PLANNING, ZONING, & BUILDING DEPARTMENT
PZ&B Staff Combination Memorandum: Architectural Commission and Town Council

SUBJECT: ARC-24-0073 (ZON-24-0037) 353 EL BRILLO WAY

ARC-24-0073 (ZON-24-0037) 353 EL BRILLO WAY. The applicants, Eduard De Guardiola & Melissa G. Bridgers, have filed an application requesting Architectural Commission review and approval for a closet addition, requiring variances for a setback encroachment and lot coverage overage. Town Council shall review the application as it pertains to zoning relief/approval.

Existing south elevation at El Brillo Way.

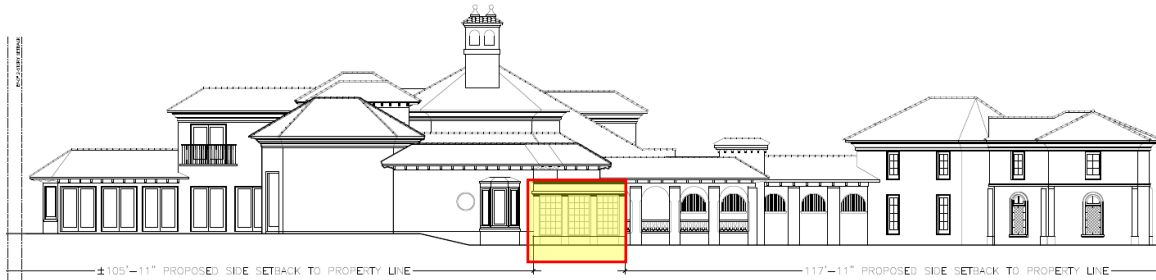
The subject property is located waterfront at the western end of El Brillo Way on the north side of the street. The siting of the house is somewhat irregular, with the “side” of the home facing the street (El Brillo Way). The addition is proposed on this street facing “side” of the home, however, this area is technically considered the front yard setback area. The addition is relatively minor compared to size of the existing structure, and is designed with a flat roof and a trellis on the exterior walls for climbing plants, with other details to match the existing residence. The addition is proposed over existing courtyard paved area, and the applicant affirms that no landscape open space will be lost due to the addition.

Proposed south elevation at El Brillo Way.

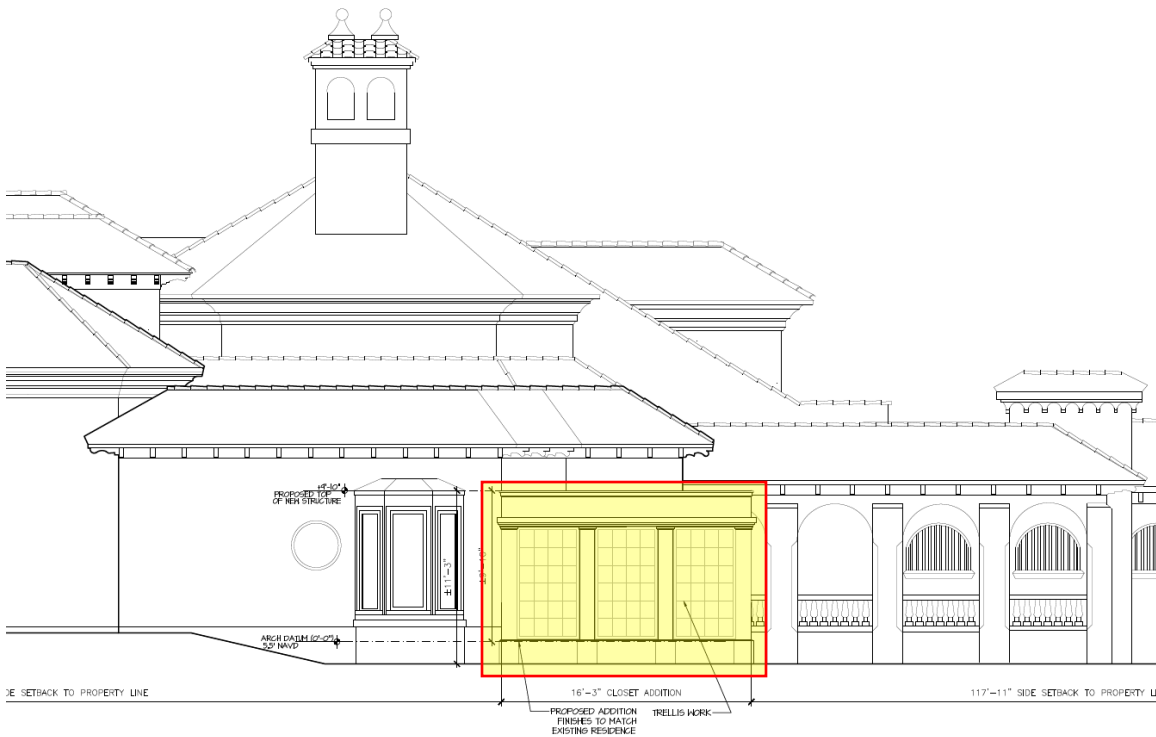
The design requires two variances as proposed. The existing residence is built up to the 35' front setback line, and is just below the maximum lot coverage at 24.9% existing. The small closet addition will require a setback variance to permit a 26.5' front yard setback in lieu of the 35' minimum setback required, and a variance for lot coverage of 25.7% in lieu of the 25% maximum permitted.
